European COmpetitiveness in Commercial Hybrid and AutoMotive PowertrainS

Horizon 2020 | GV-4-2014 | Hybrid Light and Heavy Duty Vehicles

Deliverable No.	ECOCHAMPS D2.4	
Deliverable Title	Modular System for Hybrid CV Components as Baseline for Standardization	
Deliverable Date	2018-04-30	
Deliverable Type	REPORT	
Dissemination level	Public (PU)	
Written By	Sebastian Wagner (FhG) Jakub Rehor (FhG) Nicolas du Bois (Daimler) Tassilo Pflanz (MAN) Roberto Mantia (IVECO) Guus Arts (DAF)

Figure 2-1 Determination of requirements that should be standardized and development of standard proposals.

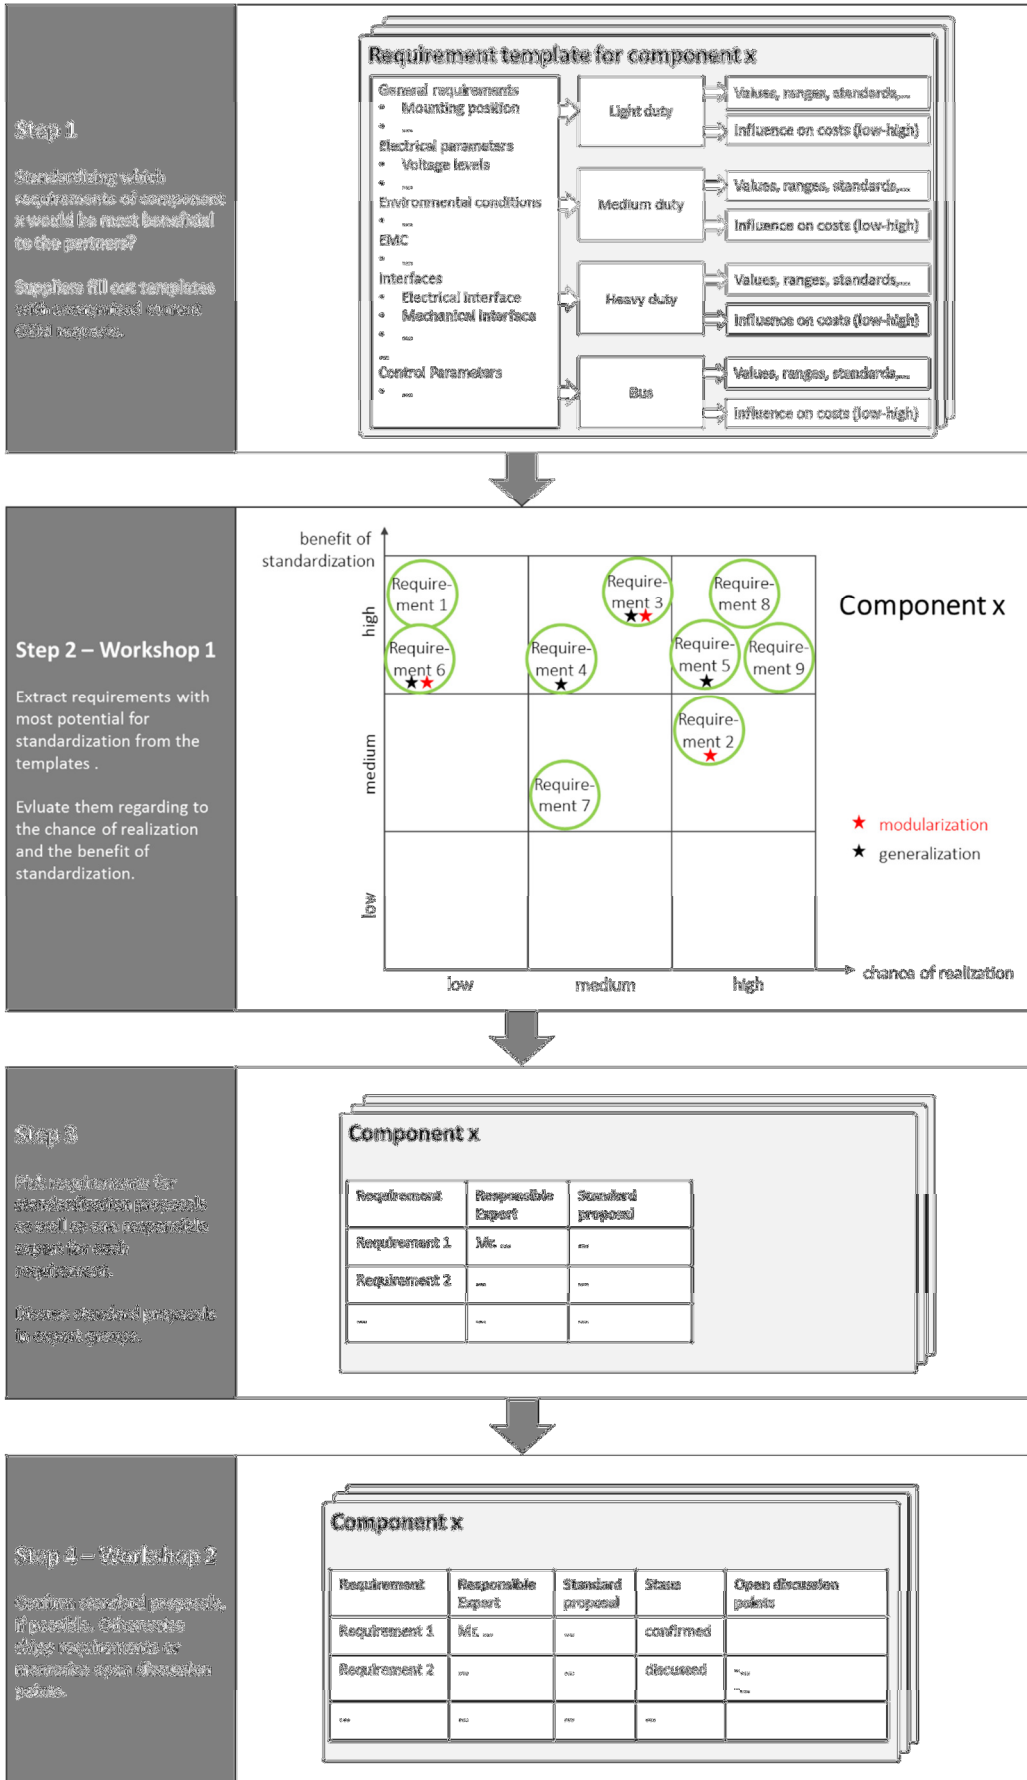
One positive aspect of this project is the fact that it is not jumping directly into a discussion of specific characteristics for components and devices but that it starts on the requirement level (Chapter 1.2.3, Figure 2-1) and that it also considers all important methods (e.g. Functional Safety, DV testing, EMC, Noise assessment etc.). The requirements-based approach allows an early assessment of expected benefits from standardization as well as a structured proceeding for the following workstreams.
